IEEE P802.3dg Downshift/Upshift State Diagram Fix

Peter Jones, Cisco Systems

October 2025

Figure 98D-1 Downshift state diagram

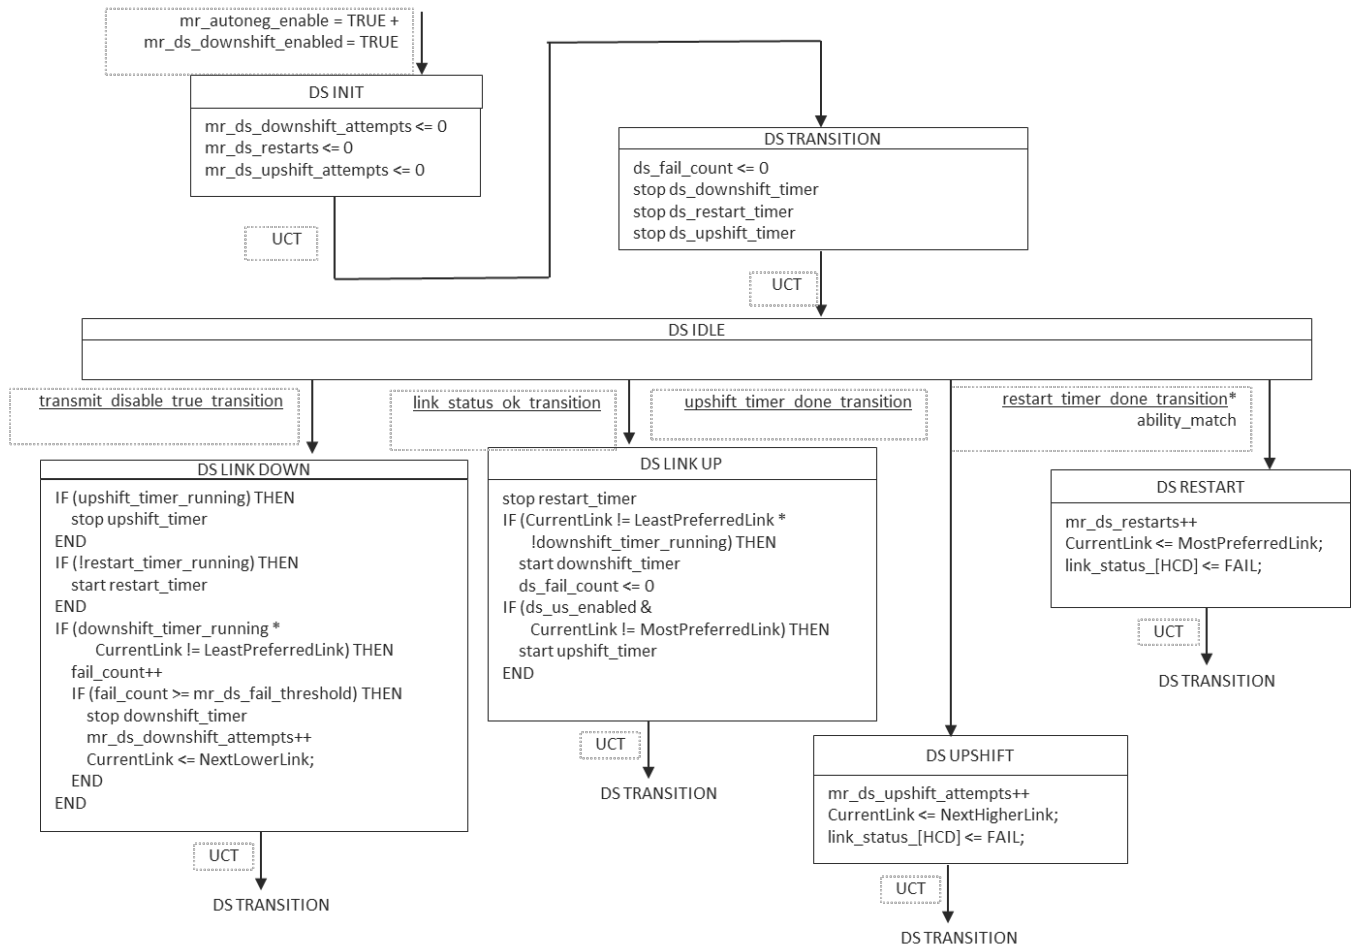
Replace Figure 98D-1 with the following (additions/changes marked with underline):

Add the following variables to the list in 98D.2.2 Variables.

`link_status_ok_transition`

Variable set as TRUE when the value of `link_status[HCD]` changes from any state to OK and set FALSE otherwise.

`restart_timer_done_transition`

Variable set as TRUE when `ds_restart_timer_done` changes from deasserted to asserted and set FALSE otherwise.

`transmit_disable_true_transition`

Variable set as TRUE when the value of `transmit_disable` changes from false to true and set FALSE otherwise.

`upshift_timer_done_transition`

Variable set as TRUE when `ds_upshift_timer_done` changes from deasserted to asserted and set FALSE otherwise.
